SUBJECT: James A. FitzPatrick Nuclear Plant
Docket No. 50-333
Individual Plant Examination

JAMES A. FITZPATRICK NUCLEAR POWER PLANT
INDIVIDUAL PLANT EXAMINATION (IPE)

RESPONSE TO
REQUEST FOR ADDITIONAL INFORMATION (TAC NO. M74411)

Figure 8.1 RHR System Loop A Component Maintenance Unavailability Allocation

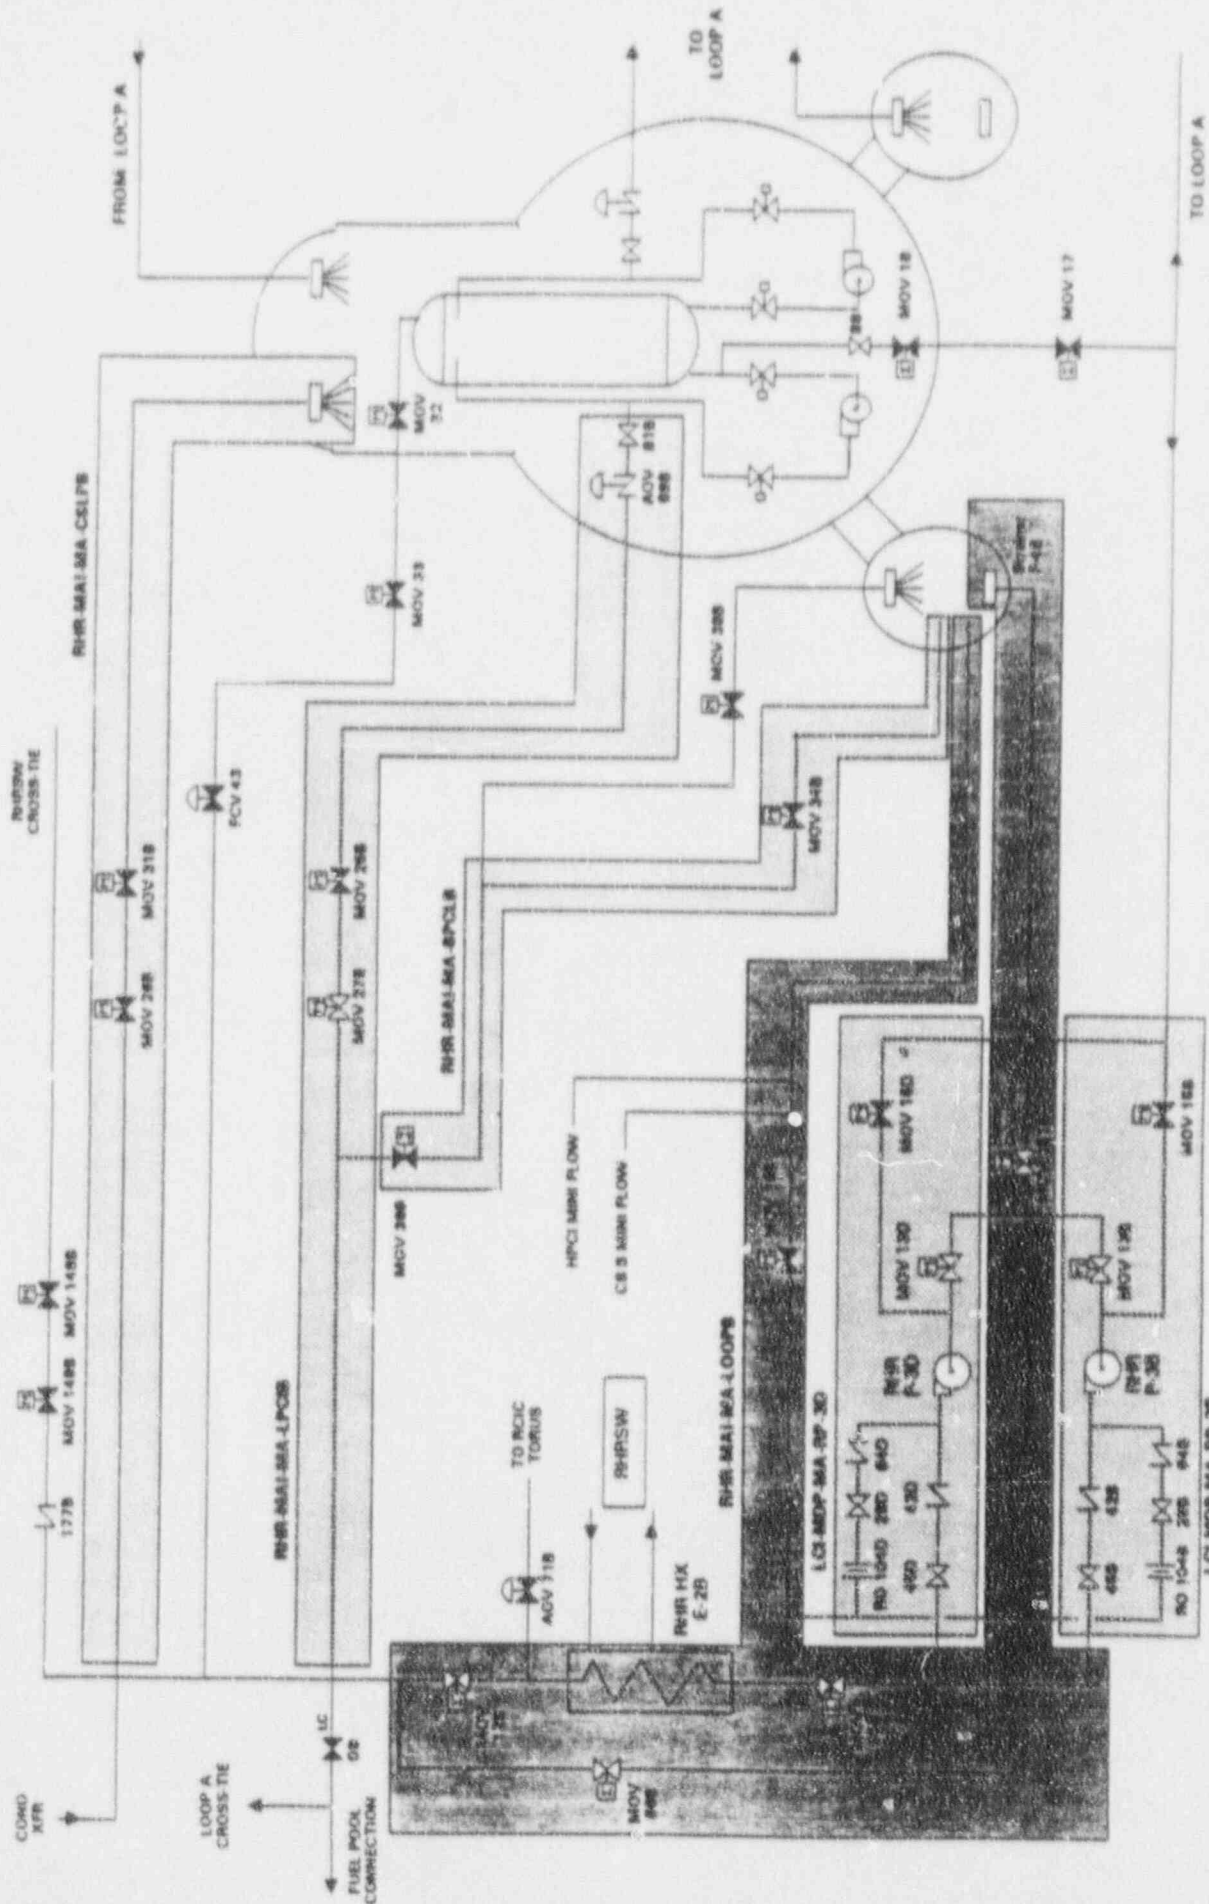
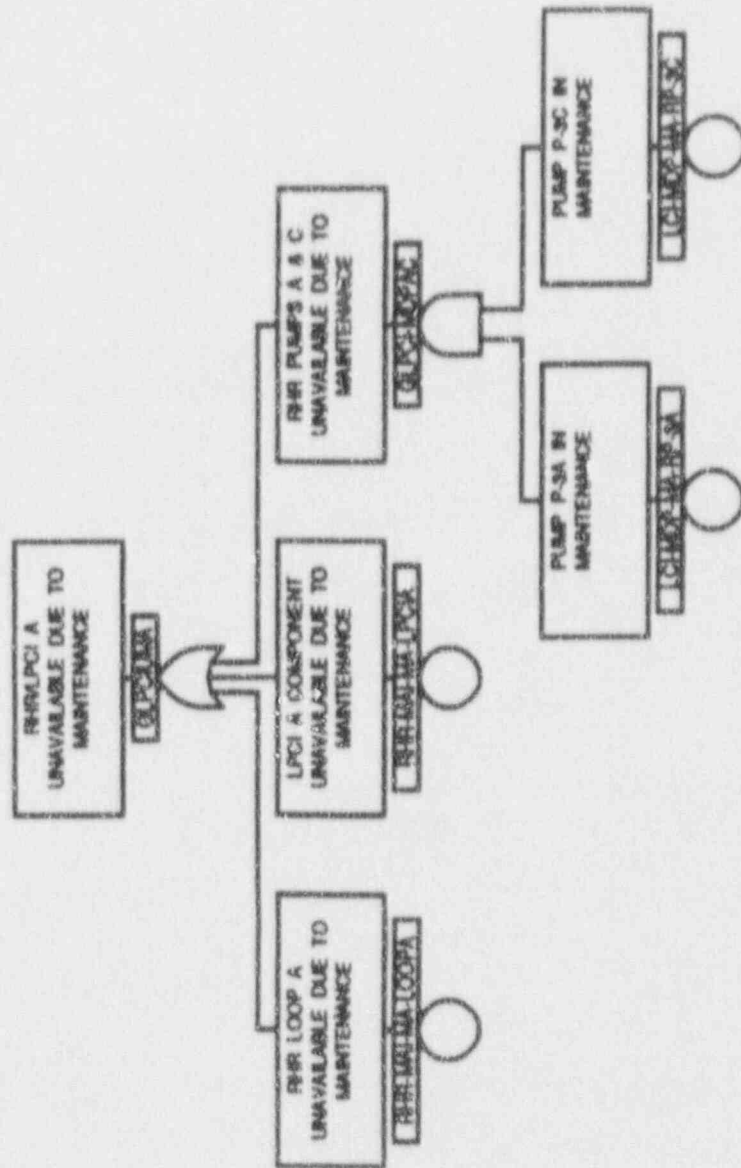
Estimates of train level unavailabilities occasioned by test and maintenance were based on the daily plant status reports (DSRs) issued at JAF supplemented by data from the plant logs and the maintenance work order packages. The DSRs list all systems and components unavailable on a given day, but, because they do not distinguish between test and maintenance unavailability, no distinction was made between them in the data used. The use of plant data in estimating unavailabilities is described in the JAF IPE, Volume 2, Appendices B and D.

RHR system unavailability was estimated from out-of-service hours recorded for each component in the DSRs and other sources of plant data. The RHR system has two trains each of which has two pumps. Train and pump unavailabilities were depicted in the mutually exclusive basic events RHR-MAI-MA-LOOPA, RHR-MAI-MA-LOOPB, and LCI-MAI-MA-RP-3A/B/C/D.

The unavailability events were incorporated in the system fault trees as appropriate. For example, in the depiction of RHR/LPCI mode maintenance unavailability, the unavailability of train A in the maintenance mode was represented by three events (Figure 8.3): the unavailability of components in loop A (RHR-MAI-MA-LOOPA); the unavailability of valves in the LPCI injection path (RHR-MAI-MA-LPCIA); and the unavailability of pumps P-3A and P-3C and their associated equipment. The unavailability of pumps P-3A and P-3C is represented by an AND gate with basic events LCI-MDP-MA-RP-3A and LCI-MDP-RP-3C as inputs. It will be noted that maintenance unavailability events are not duplicated. Maintenance that would violate technical specifications (e.g., the simultaneous unavailability of both RHR trains) was eliminated from the cut sets during sequence quantification.
